CHANGE ORDER

ORDER NO.: 3
DATE: 4/17/2024
AGREEMENT DATE: 2/15/2023

NAME OF PROJECT: Bell Farms and Presidential Glen Lift Station Expansion
OWNER: City of Manor

**BELL FARMS LIFT STATION
SURGE RELIEF VALVE
PIPE RE-ADJUSTMENT**

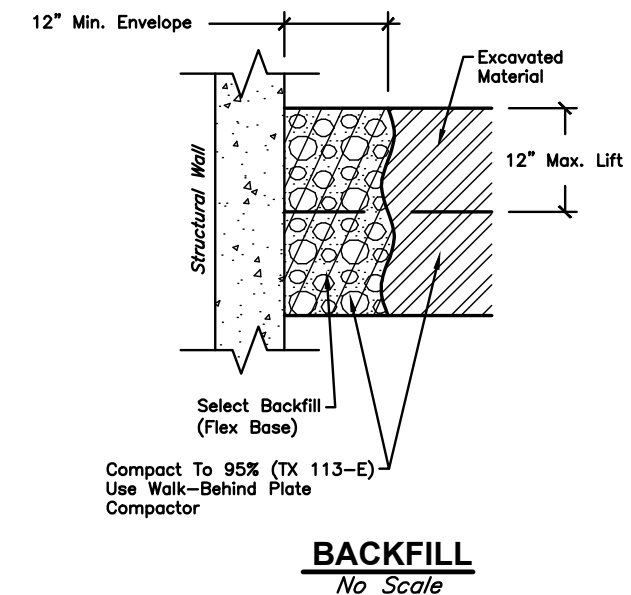
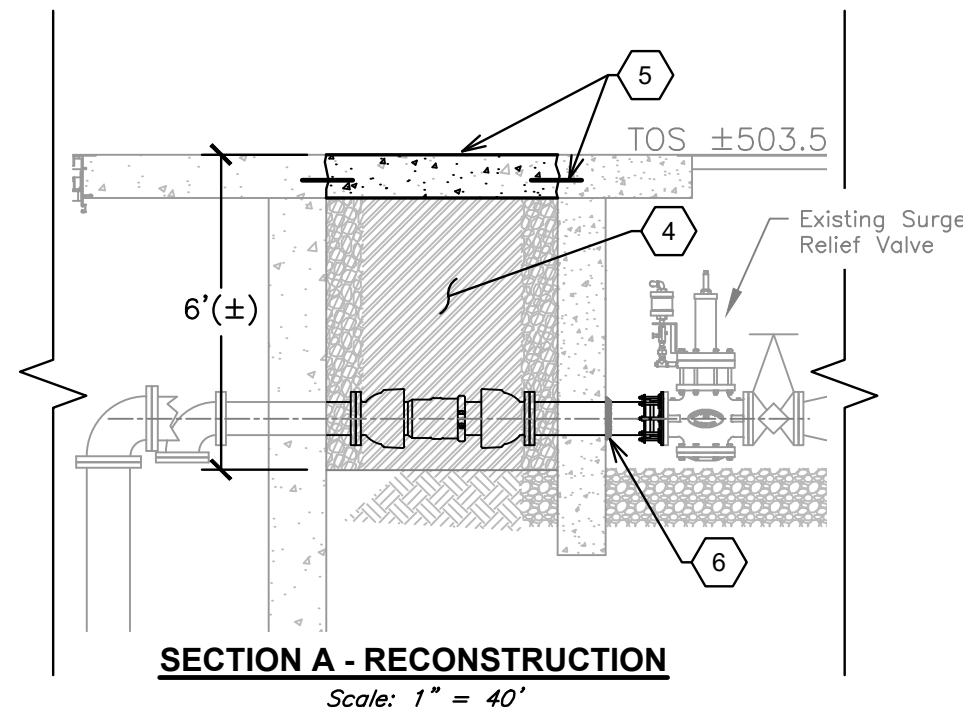
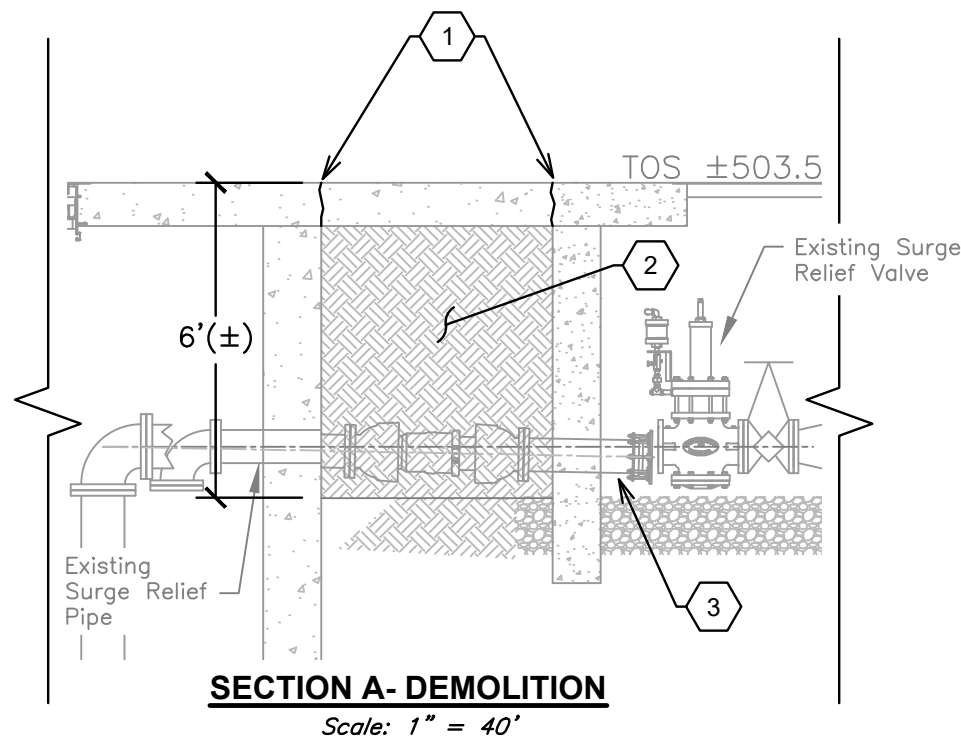
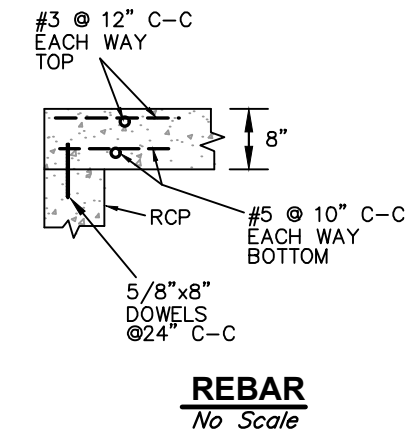
Item No. 1– Add 1 LS Change Order Item C.O. 3.-1, Adjust and center the surge relief valve piping to the surge relief valve at the Bell Farms Lift Station @ \$13,169.42/LS = \$13,169.42

CO REQUEST TO MODIFY SURGE RELIEF PIPING TO ALIGN AND BOLT UP TO NEW VALVE

1. SAWCUT THE SLAB
2. EXCAVATE AND REMOVE MATERIAL TO THE SURGE RELIEF VALVE PIPING.
3. CONTRACTOR TO ADJUST THE SURGE RELIEF PIPING TO BE CENTERED WITH THE SURGE RELIEF VALVE AND ALLOW CONNECTION.
4. BACKFILL WITH FLOWABLE FILL.
5. DOWELL IN TO MATCH WHAT WAS EXISTING, TIE REBAR, AND POUR CONCRETE TO MATCH THE EXISTING SLAB.
6. PATCH UP THE CHIPPED CONCRETE AROUND THE SURGERELIEF VALVE PIPING

MANHOLE GRADE RING

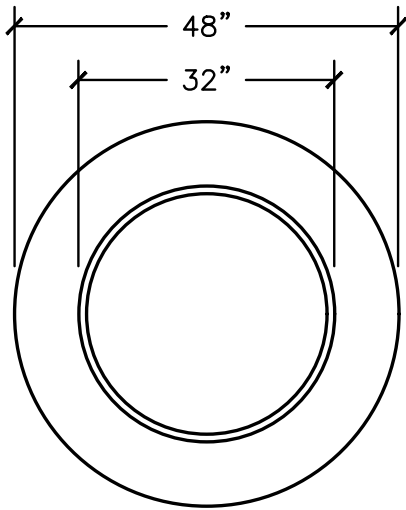
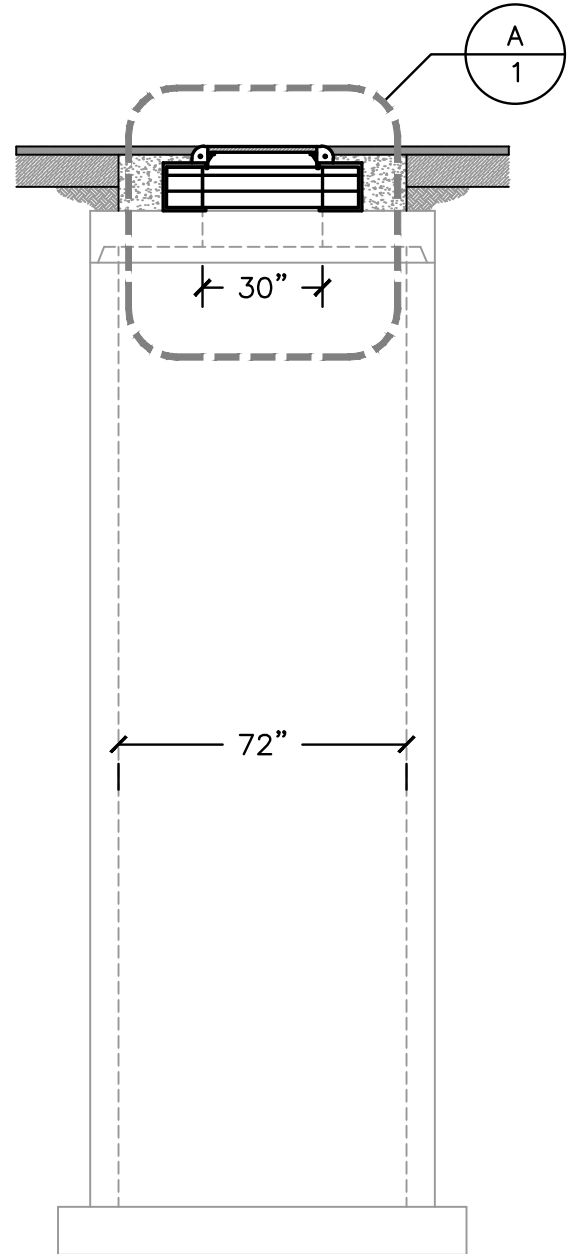
Item No.2 - Add 1 LS Change Order Item C.O. 3.-2, Installation of grade ring adjustments for the new wet well at the Presidential Glen Lift Station to bring it to top of the grade @ \$6,641.76/LS = \$6,641.76

CO REQUEST, INSTALL GRADE RINGS WITH RING AND COVER ON THE NEW WET WELL, BELL FARMS LIFT STATION

1. DIMENSIONS WILL NEED TO BE FIELD VERIFIED BY CONTRACTOR.
2. CONTRACTOR TO NOTIFY ENGINEER OF ANY NECESSARY ADJUSTMENTS NEEDED FOR CONSTRUCTION.
3. REFER TO CITY OF MANOR STANDARD DETAIL WW-03.
